ADDENDUM A Staff Report: Z-72-25-6

Proposal: Commercial Uses

Location: Northeast corner of 17th Street and

The purpose of this addendum is to revise the language for Stipulation No. 1 to reflect updated elevations submitted by the applicant.

Elevations date stamped August 18, 2025

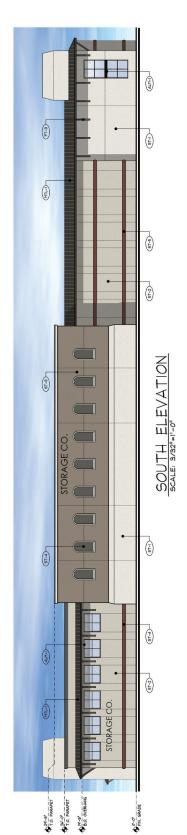
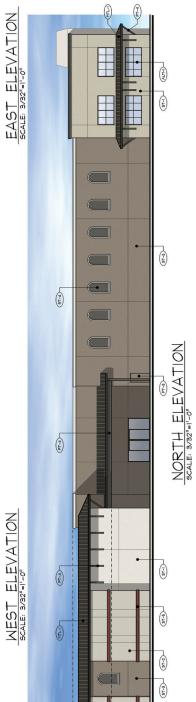
The North Mountain Village Planning Committee is scheduled to hear this case on August 20, 2025. On August 18, 2025, the applicant submitted revised elevations to reflect ongoing discussions with community members. The revised elevations depict a color scheme that contains natural earth tones. Staff recommends modifying Stipulation No. 1 to reflect the new submittal date and to ensure the elevations develop as proposed.

- 1. The development shall be in general conformance with the site plan and elevations date stamped May 27, 2025, AND THE ELEVATIONS DATE STAMPED AUGUST 18, 2025, WITH SPECIFIC REGARD TO THE COLOR PALETTE, as modified by the following stipulations and approved by the Planning and Development Department.
